Service Bulletin

No. : MZ04-080 Rev. **Date:** December 5, 2006

Model: SA8260, SA17S1

Subject: Can not playback hybrid Super Audio CD's.

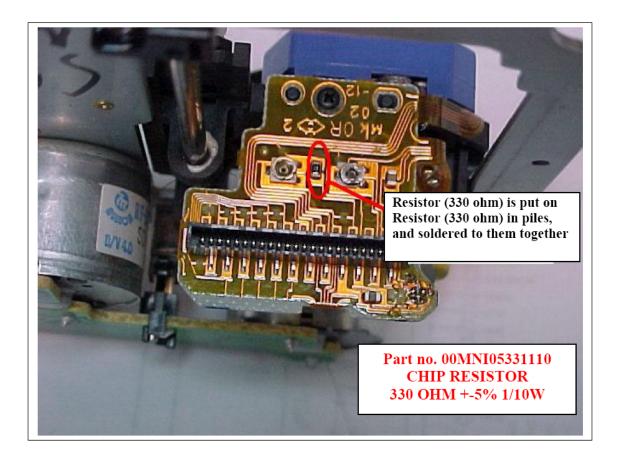
Symptom: 1. Can not playback Super Audio CD (low reflection DISC), "ERROR" is indicated on the display of the Unit. 2. Can not read TOC with low reflection DISC. The unit stops during playback Super Audio CD.

In order to keep HF level to about 2mA to 5mA the laser current is increased.

- 1. CHIP RESISTOR (330 OHM) is added to Laser pickup PCB.
- 2. Add the CHIP RESISTOR (0 OHM) to Laser pickup PCB and adjust the trimming potentiometer for the proper HF level.

4. CAUTION Optical pick up and Servo Board

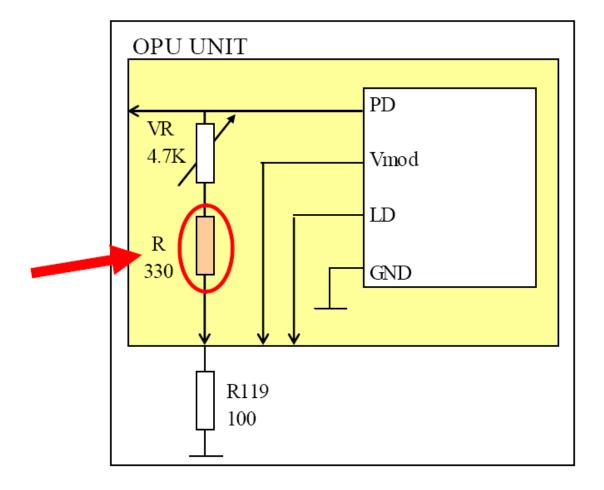
When removing the flat wire between Optical pick up and Servo Board (PV16), Solder the four lands pointed by arrows to short the circuit.

Otherwise the LASER DIODE may be damaged by static electricity.

SACD-HF OUTPUT ADJUSTMENT PROCEDURE

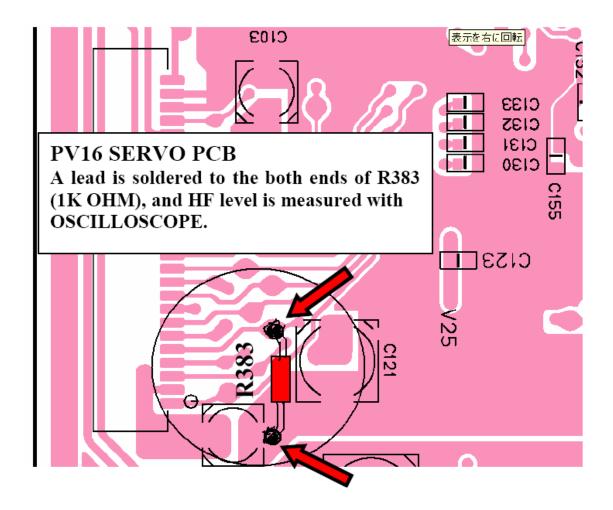
- 1. First, HF level of SACD (low reflection DISC) is checked with an OSCILLOSCOPE. The HF level across R383 (1Kohm) of the following figure (see below). The playable range is 330mV or more.
- 2. When HF level is less than 330mV, Change R330 (330 OHM) to 0 OHM.
- 3. Even if R330 changes to 0 OHM, When the HF level falls outside allowable range, the trimming potentiometer needs to be adjusted. (<u>Caution</u>: A problem may occur with a high reflection DISC if the HF level is raised too much.)
- 4. Playback SACD (low reflection DISC) and the voltage of the both ends of R112 or R113 is measured. Check the measurement voltage it should be 544mV or less. When the measured voltage is over 544mV, replacment of the PICK UP UNIT is required.

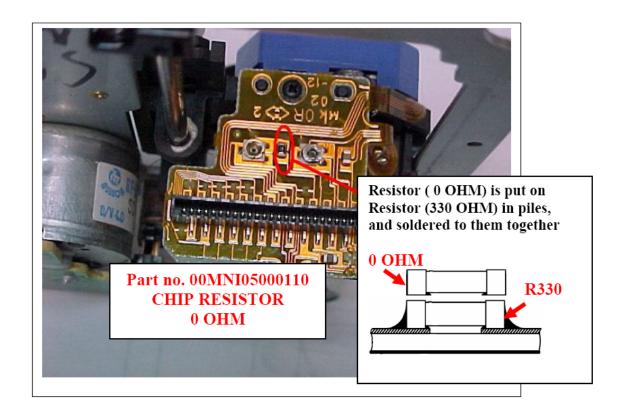
1. First, Check the HF level of SACD (low reflection DISC) with OSCILLOSCOPE.

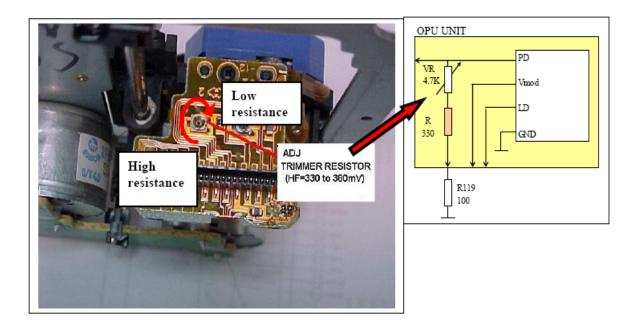
2. When HF level is less than 330mV, Change the R330 (330 OHM) to 0 OHM.

- 3. Even if R330 is changed to 0 OHM, When the HF level falls outside allowable range, the trimming potentiometer needs to be adjusted.
- 3-1) First, turn OFF the Unit, adjust the variable resistor by rotating it by eye measurement
- 3-2) First, the resistance of the both ends of trimming potentiometer is measured.
- 3-3) Then, resistance is made to increase from measured value by about 10% to 20%.
- 3-4) Set the HF level to 330mV to 380mV.

Be careful! The trimming potentiometer adjustment is very critical.

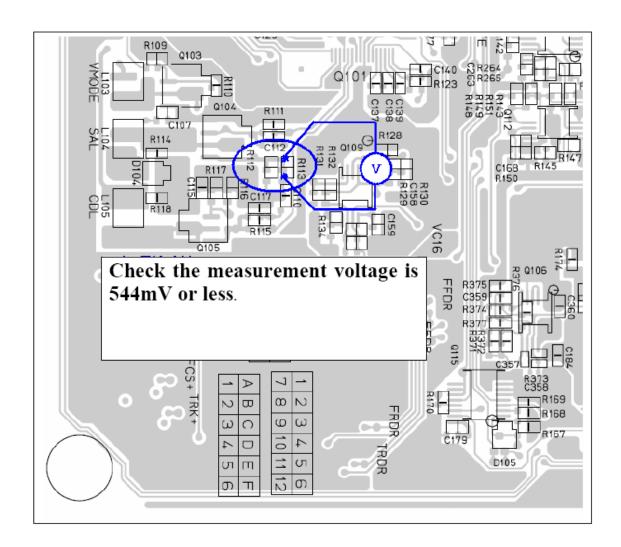
4. Playback SACD (low reflection DISC) and the voltage of the both ends of R112 or R113 is measured. Check the measurement voltage should be 544mV or less. (see picture below)

When measurement voltage is over 544mV, replacing of PICK UP UNIT is required for safety.
